**ADDENDUM NO. 3 TO PROJECT NO. 44190**

**CONSTRUCTION WORK, HVAC WORK, PLUMBING WORK, AND ELECTRICAL WORK  
PROVIDE FIELD OPERATIONS BUILDING  
STATE PREPAREDNESS TRAINING CENTER  
5900 AIRPORT ROAD  
ORISKANY, NY 13424**

December 20, 2011

C-001

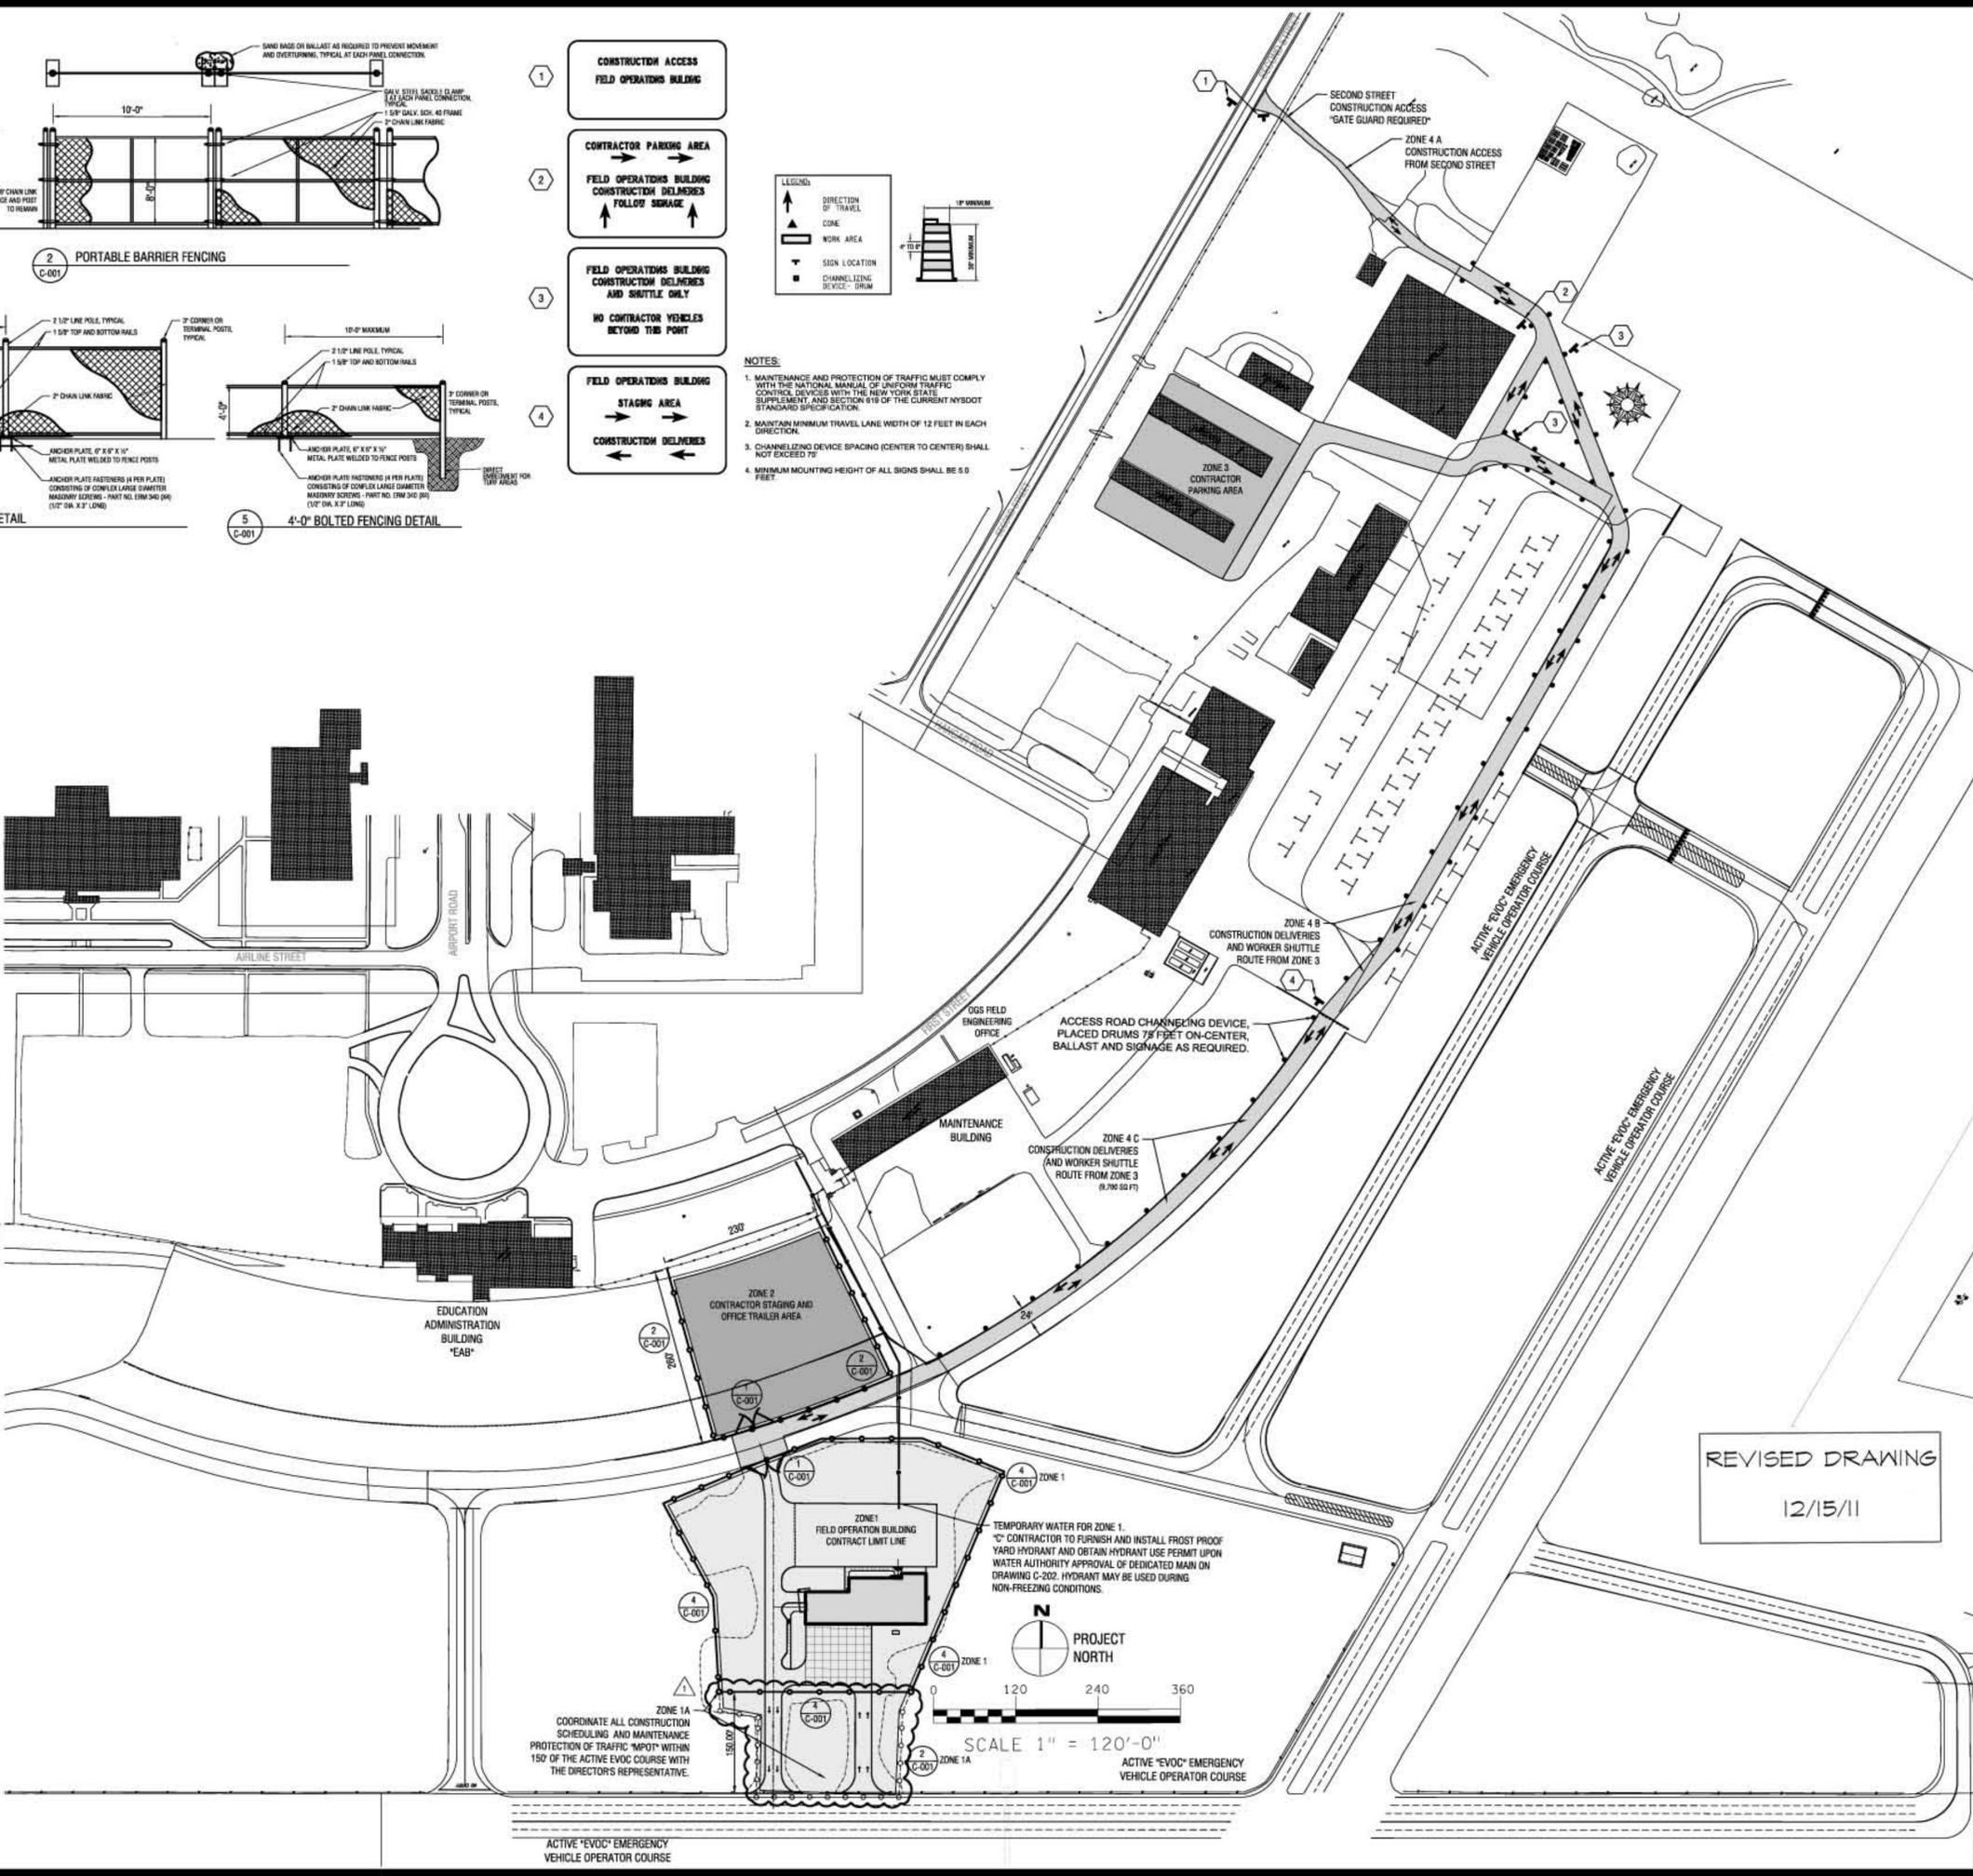
- "A. Drawing No. C-100 STAGING PLAN identifies the access route for the contractors of all the trades.
    1. Supervisors from each Contractor will be required to shuttle/carpool workers in vehicles clearly marked with the company name from the designated parking area to the construction site.

2. Only one vehicle/shuttle per trade will be allowed in the staging area.
    3. The Construction Work Contractor will be required to provide a security guard to operate the existing access gate during work hours established by the facility thru the Director's Representative for each working date, to enforce ID badges and limit access to contractors and deliveries.

4. The security guard is required for the duration of the Work through substantial completion."
4. Page 015000-5, Subparagraph 1.12 A.1.: Delete this Subparagraph in its entirety and replace with the following

- "1. Park vehicles in areas where directed. Refer to Drawing No. C-001 Staging Plan for parking area designation."
